CLIENT:	BL Merthyr Ltd
PROJECT:	Cyfarthfa Retail Park – Drive Through
SUBJECT:	Ecology response to Matt Davies’s Internal Memorandum to David Cross (dated 30/08/2024)
JOB NO.:	CA13316 – 001 V1.0 – FINAL
DATE:	04/03/2025
PREPARED BY:	Abigail Coe (Associate Director)
REVIEWED & APPROVED BY:	Sally Caveill (Technical Director)

Technical Note

Table 1 – Ecological response to Matt Davies’ comments		
Matt Davies’ Comment		WA Response
1.	The <i>Executive Summary</i> outlines a list of receptors upon which may be affected adversely due to the proposed scheme in the absence of mitigation. There is no mention of adverse impacts on the habitats present on site (neutral grassland, scattered scrub, scattered trees, dense scrub). Amendments required.	The areas of these habitats are small in size and considered to be common and widespread habitats. Therefore, the habitats within the site boundary are not considered to be of ecological importance at above the site scale. Therefore, no mitigation for the loss of these habitats is considered necessary; however, these habitats could support protected species and therefore reasonable avoidance measures in respect to the protection of these species wi

REVISION	DETAILS	DATE	DRN	CHK'D	APP'D
CLIENT					
BL Merthyr Ltd					
PROJECT					
Cyfarthfa Retail Park - Drive Through					
DRAWING TITLE					
Ecological Enhancement Plan					
DRG No.	CA13316/001				REV A
DRG SIZE	A3	SCALE	1:250	DATE	19.02.25
DRAWN BY	GR	CHECKED BY	AC	APPROVED BY	SC

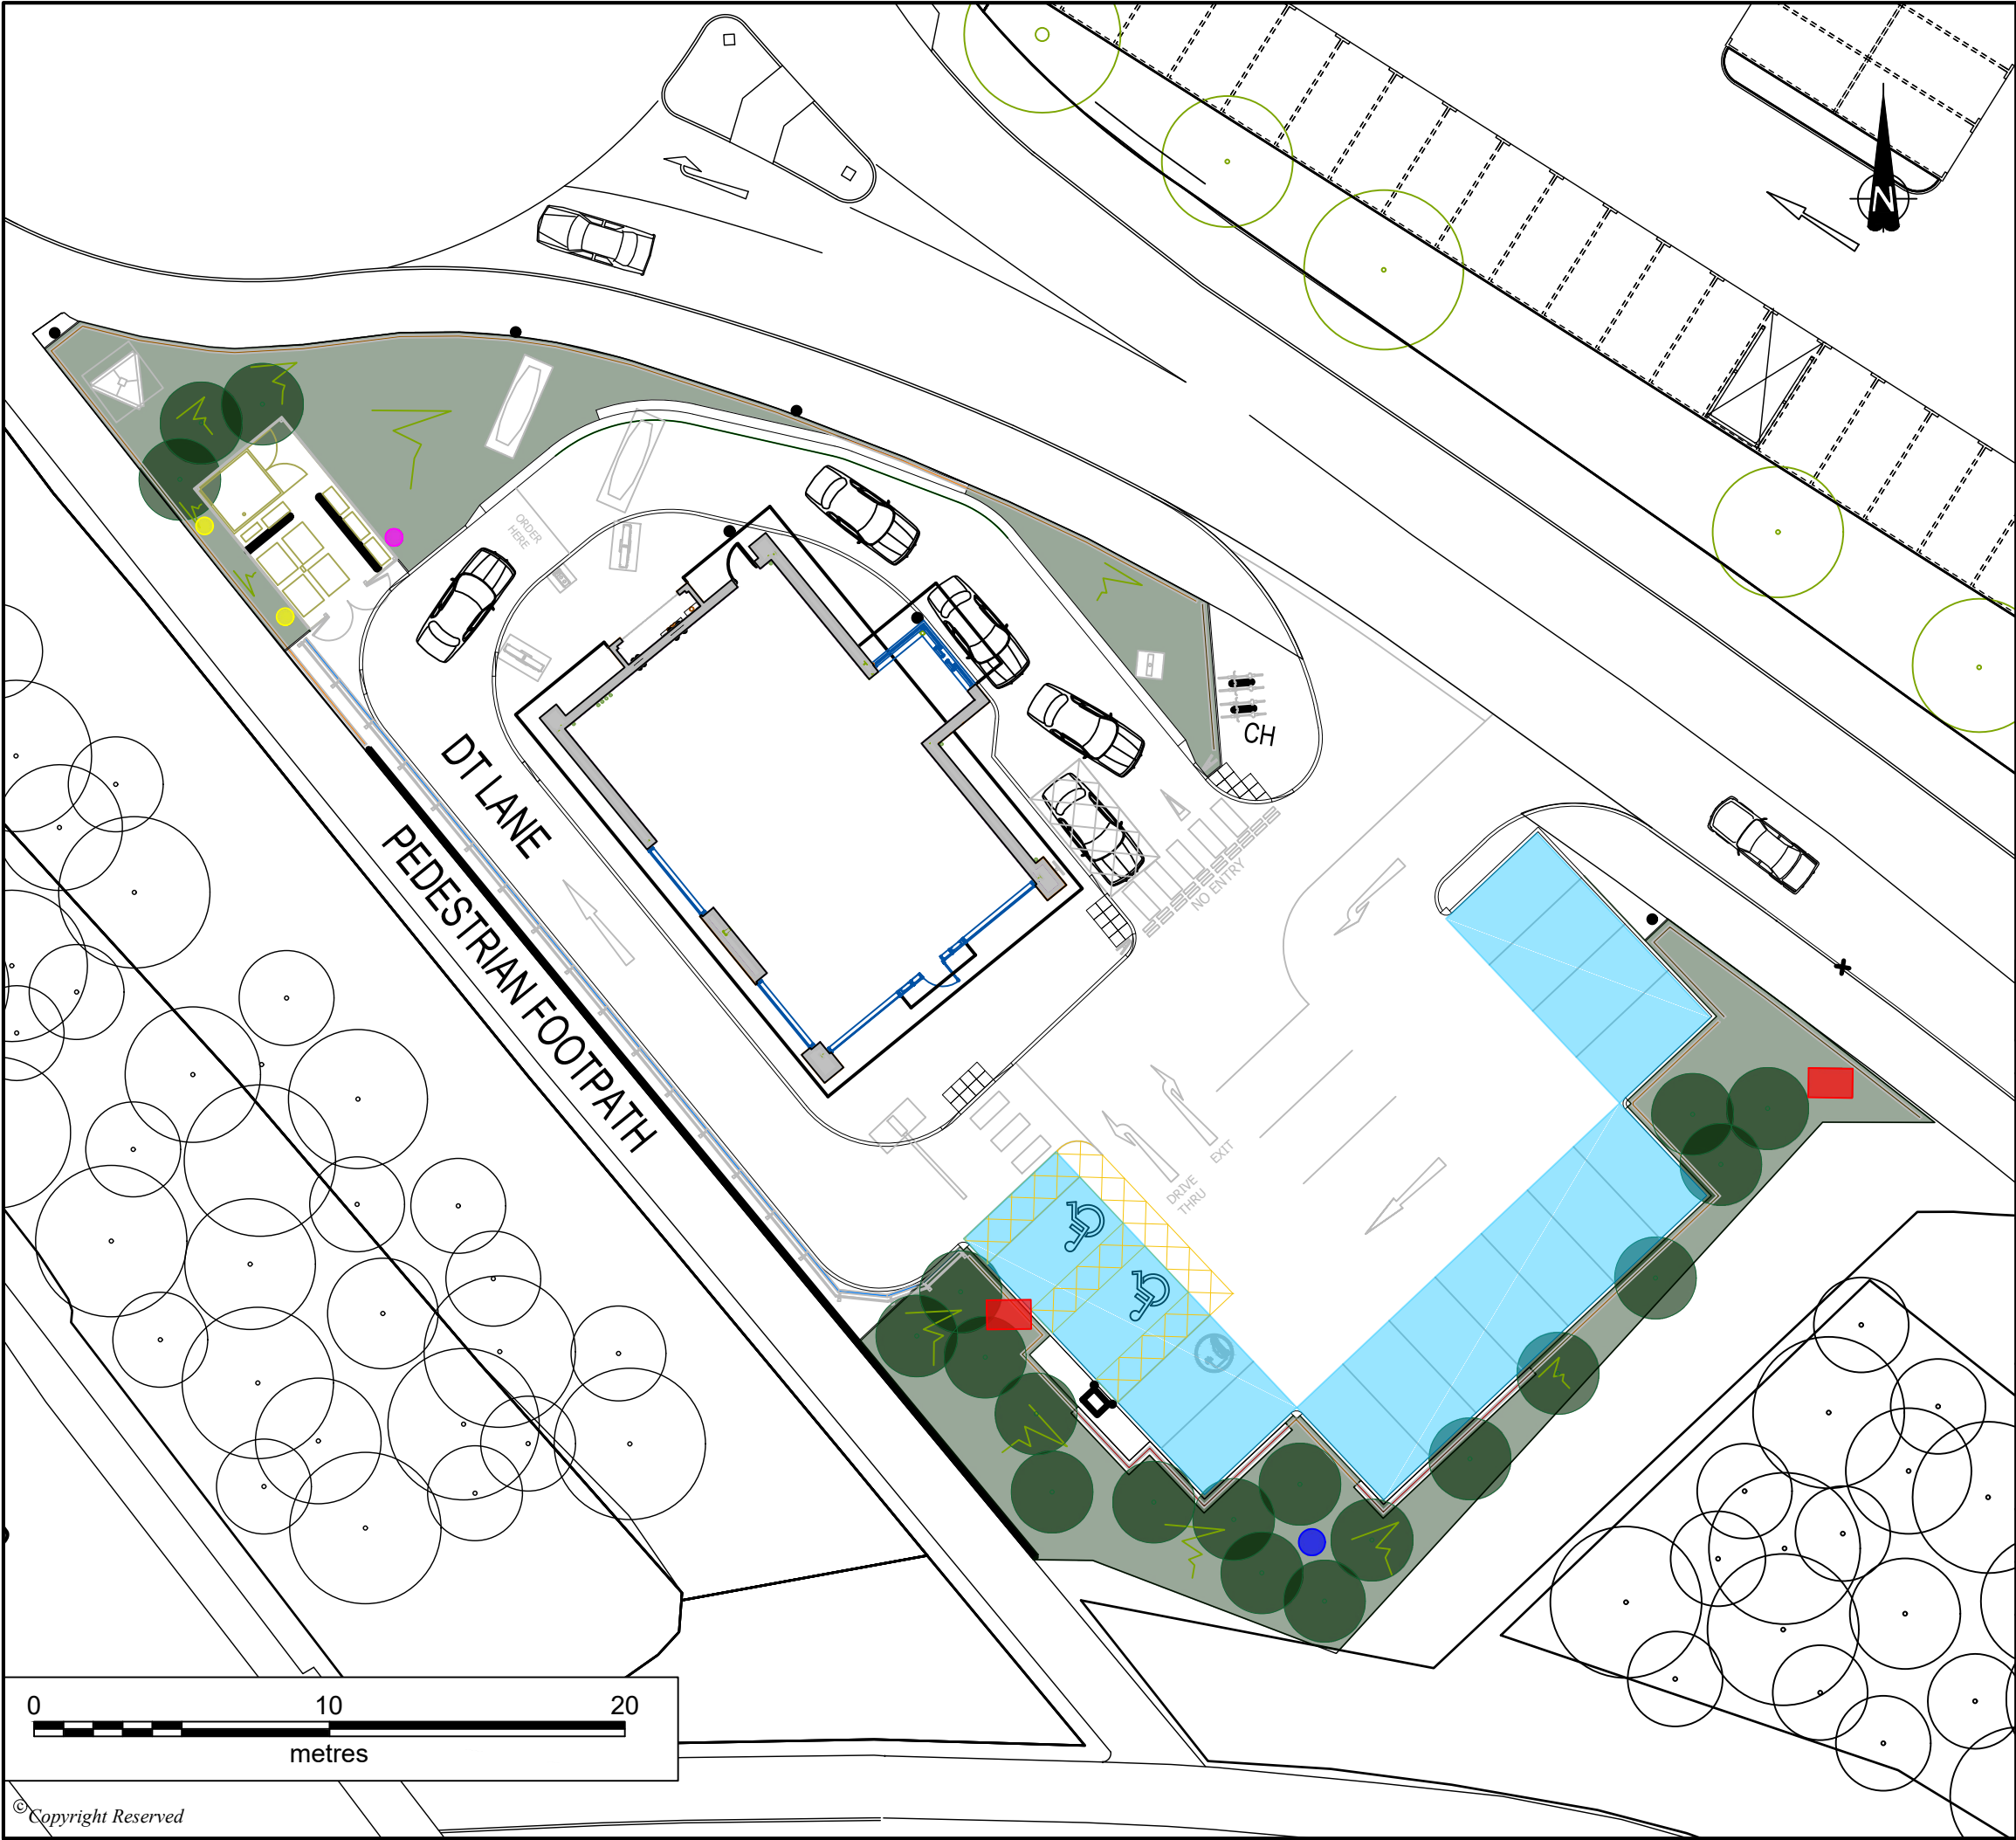
7.	Enhancements Full details of the enhancement measures are required, including model type, specifications, design, position, orientation etc (i.e., for bat and bird boxes, hibernacula, woodpiles/loggeries, bug hotels). Wildlife box models will be constructed from woodcrete or woodstone for reasons of longevity. Enhancements must be clearly marked on all relevant architect plans/drawings/elevations.	An Ecological Enhancement Plan (CA13316/001) has been prepared which includes the full details and locations of the above detailed ecological enhancement measures (see attached).

- Open-fronted nest box (such as Eco Robin Nest Box or similar) mounted at 2m height on the south-western side of the wooden fence around the refuse store
- One insect hotel (such as National Trust Insect Tower or similar) mounted at 2m height on the eastern side of the wooden fence around the refuse store
- Log pile directly adjacent to the newly planted hedgerow approx. 1m x 1m
- Hibernacula adjacent to the newly planted hedgerow created from rubble and soil approx. 1m x 1m
